FOUNDATION INVESTIGATION REPORT BY -  
William A. Trow & Associates Ltd. -  
Proposed Crossing over Young Creek,  
Dev. Rd. #684, Port Ryerse, Ontario.  
W.P. 701-62

FOUNDATION INVESTIGATION  
PROPOSED CROSSING OVER YOUNG CREEK  
DEVELOPMENT ROAD NO. 684  
PORT RYERSE, ONTARIO  
W.P. 701-62

SUBJECT: Bridge Site # 21-144  
W.P. 701-62  
Young's Creek Bridge  
Dev. Rd. # 684 Dist. #2

Bridge Site #21-144  
W.P. 701-62  
Young's Creek Bridge  
Dev. Rd. #684, Dist. #2.

BOREHOLE No. 3  
PROJECT Proposed Crossing over Young Creek, W.P. 701-62  
LOCATION Port Ryerse, Ontario  
HOLE LOCATION See Site Plan Drawing  
HOLE ELEVATION 604.7 ft.  
DATUM Geodetic

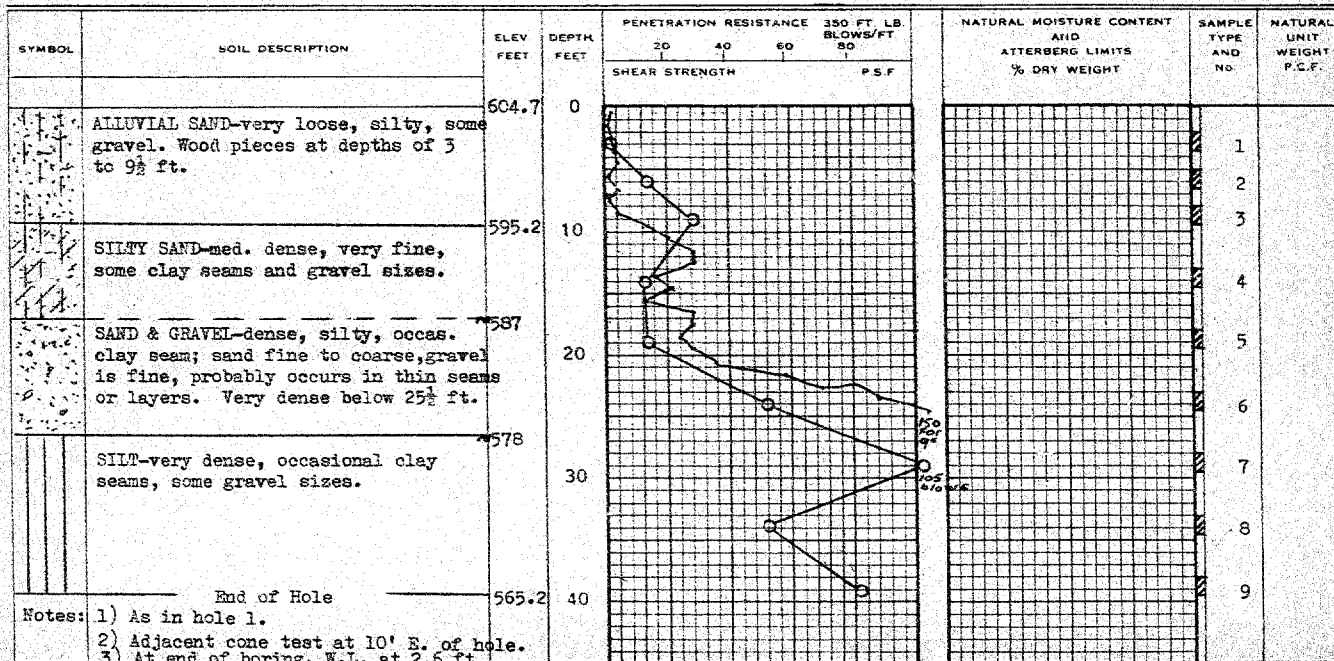
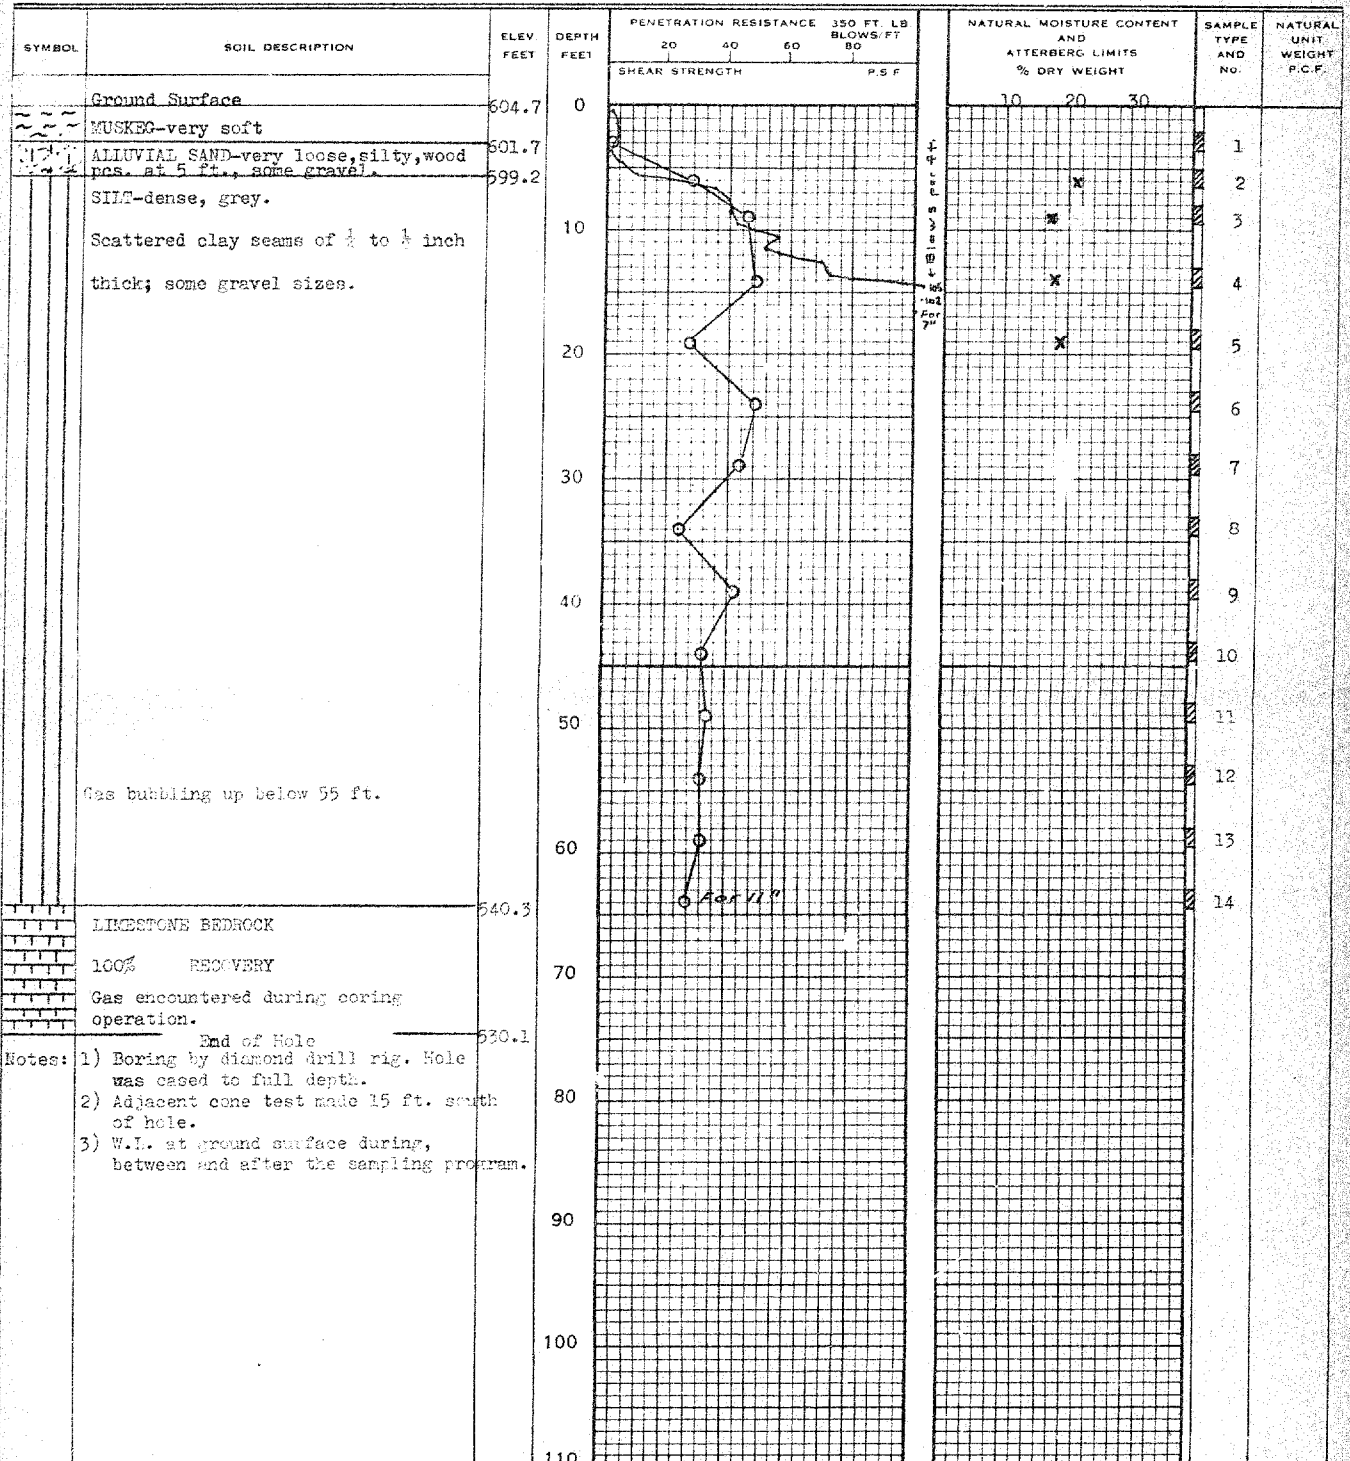
The investigation consisted of four boreholes of which three were located along the site of the proposed new structure. These three boreholes have indicated that the general subsoil stratification is relatively uniform but they have also shown that variations exist in the upper 10 to 20 ft. This is especially evident in B.H. #3.

D-5443-P1

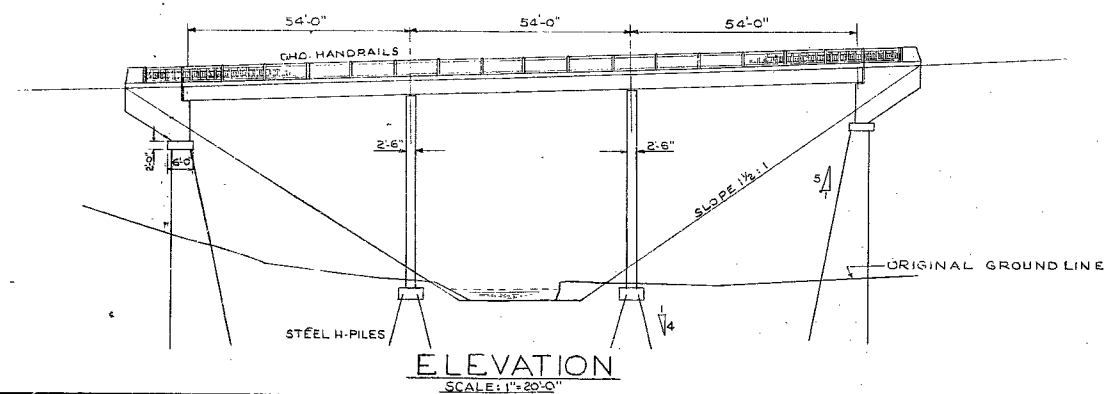
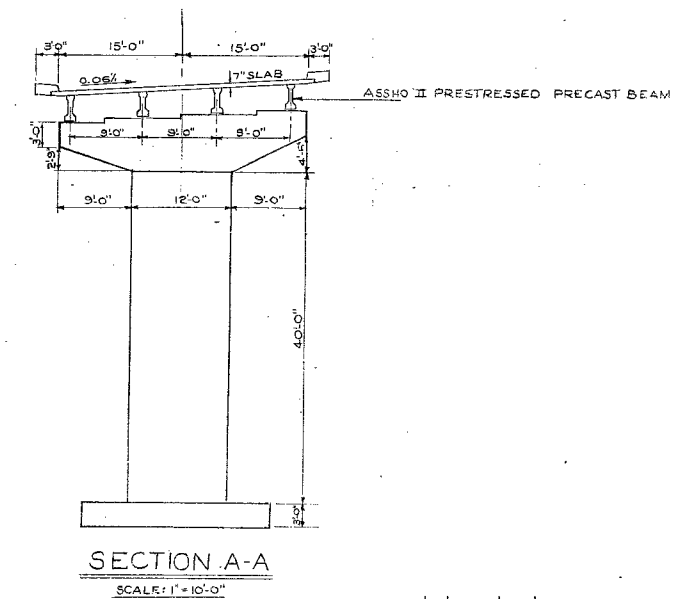
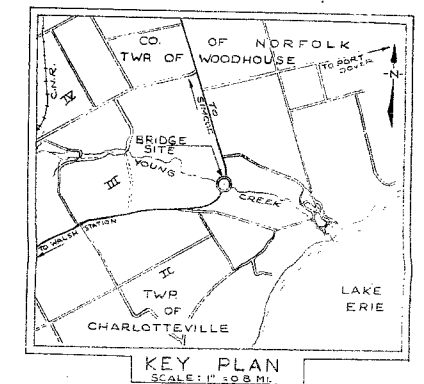
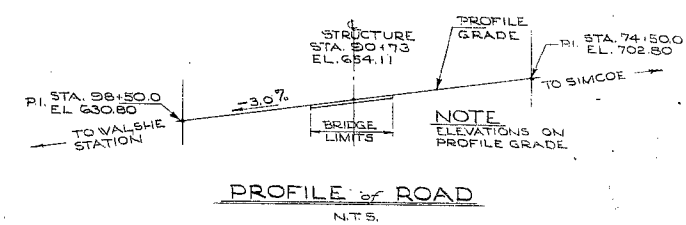
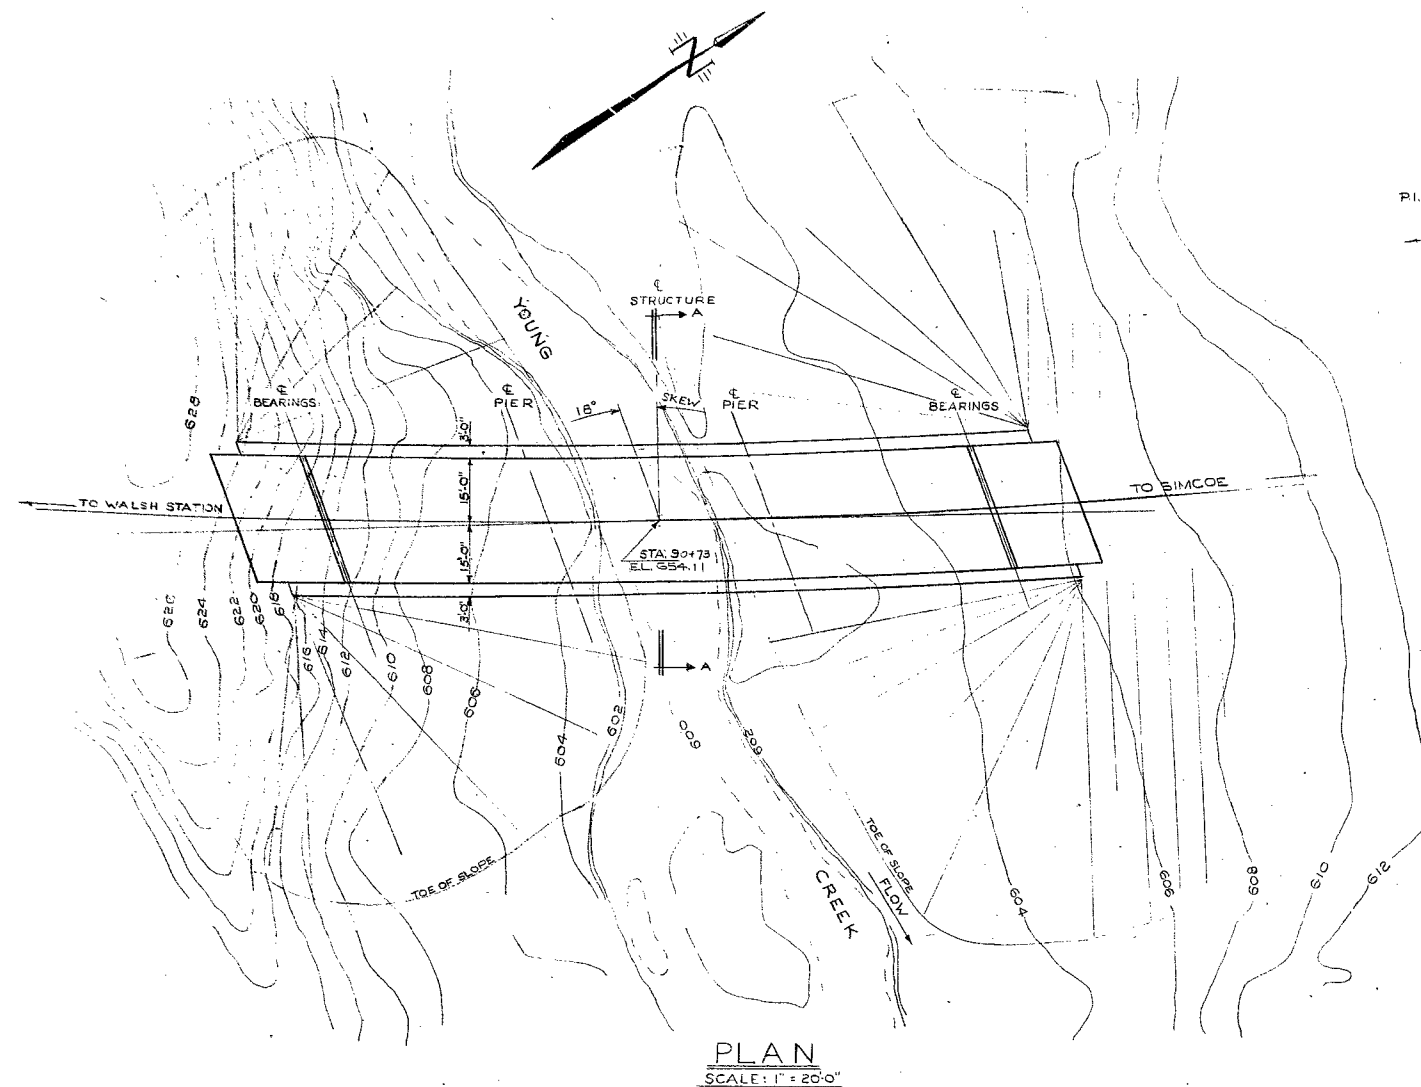
We have received your memo of January 23, 1964, with the enclosed two copies of your preliminary proposal drawing D-5443-P1 for the above structure.

The proposed solution seems much better suited for the particular subsoil conditions than the previously suggested arch culvert.

There are basically two types of piles that could be used to support the footings: end-bearing piles driven down to limestone bedrock, or friction piles driven down to approx. elevation 570.0.

Steel H-piles (12-BP-53) could be loaded up to 70 tons/pile if driven to refusal on bedrock.

Friction piles, either steel tube piles or timber piles, could be loaded up to 40 and 30 tons respectively, if driven to elevation 570.0. However, for friction piles, a pile loading test is suggested in order to establish the allowable load more reliably. It is felt that the same bearing load in the case of a friction pile could be achieved also by using an H-pile, but this would have to be substantiated by a field load test.
